TSG RAN Meeting #18
New Orleans, Louisiana, USA, 3 - 6 December, 2002

RP-020743

Title CRs (R99 and Rel-4/Rel-5 Category A) to TS 25.423
Source TSG RAN WG3
Agenda Item 7.3.3

Title:	# DSCH-RNTI in RADIO LINK SETUP FAILURE		
Source:	# RAN WG3		
Work item code:	# TEI	Date:	# 11/11/2002
Category:	# F	Release:	# R99
	Use <u>one</u> of the following categories: F (correction) A (corresponds to a correction in an earlier release) B (addition of feature), C (functional modification of feature) D (editorial modification) Detailed explanations of the above categories can be found in 3GPP TR 21.900.		Use <u>one</u> of the following releases: 2 (GSM Phase 2) R96 (Release 1996) R97 (Release 1997) R98 (Release 1998) R99 (Release 1999) Rel-4 (Release 4) Rel-5 (Release 5) Rel-6 (Release 6)

Figure 6: Radio Link Setup procedure: Unsuccessful Operation

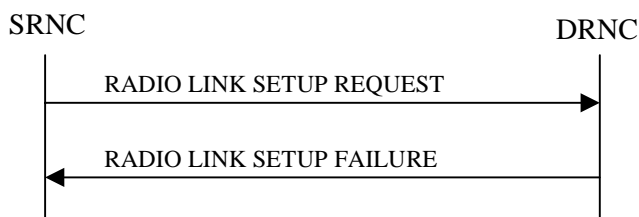
Summary of change:	# R1: Procedure text is added to the Unsuccessful Operation of the Radio Link Setup procedure to cover the inclusion of the introduced optional IE. R0: The DSCH-RNTI is added to the RADIO LINK SETUP FAILURE message. Impact Analysis: Impact assessment towards the previous version of the specification (same release): this CR has isolated impact on the previous version of the specification (same release) because only one function is impacted. This CR has an impact under the protocol point of view.

In unsuccessful case (i.e. one or more RLs can not be established) the RADIO LINK SETUP FAILURE message shall be sent to the SRNC, indicating the reason for failure. If some radio links were established successfully, the DRNC shall indicate this in the RADIO LINK SETUP FAILURE message in the same way as in the RADIO LINK SETUP RESPONSE message.

Figure 6: Radio Link Setup procedure: Unsuccessful Operation

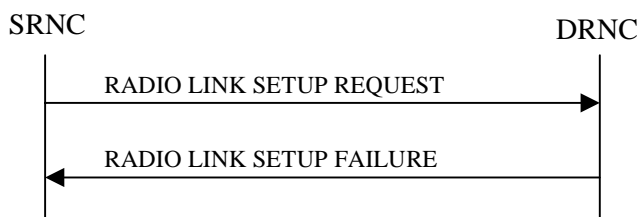
Summary of change:	# R1: Procedure text is added to the Unsuccessful Operation of the Radio Link Setup procedure to cover the inclusion of the introduced optional IE. R0: The DSCH-RNTI is added to the RADIO LINK SETUP FAILURE message.
Consequences if not approved:	# If this CR is not approved, some of the mobility scenarios with a DSCH will not be supported.

If the establishment of at least one radio link is unsuccessful, the DRNC shall respond with a RADIO LINK SETUP FAILURE message. The DRNC shall include in the RADIO LINK SETUP FAILURE message a general *Cause* IE or a *Cause* IE for each failed radio link. The *Cause* IE indicates the reason for failure.

[FDD -If some radio links were established successfully, the DRNC shall indicate this in the RADIO LINK SETUP FAILURE message in the same way as in the RADIO LINK SETUP RESPONSE message.]

Figure 6: Radio Link Setup procedure: Unsuccessful Operation

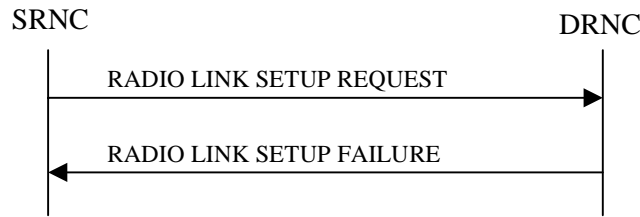
Summary of change:	# R1: Procedure text is added to the Unsuccessful Operation of the Radio Link Setup procedure to cover the inclusion of the introduced optional IE. R0: The DSCH-RNTI is added to the RADIO LINK SETUP FAILURE message.
Consequences if not approved:	# If this CR is not approved, some of the mobility scenarios with a DSCH will not be supported.

If the establishment of at least one radio link is unsuccessful, the DRNC shall respond with a RADIO LINK SETUP FAILURE message. The DRNC shall include in the RADIO LINK SETUP FAILURE message a general *Cause* IE or a *Cause* IE for each failed radio link. The *Cause* IE indicates the reason for failure.
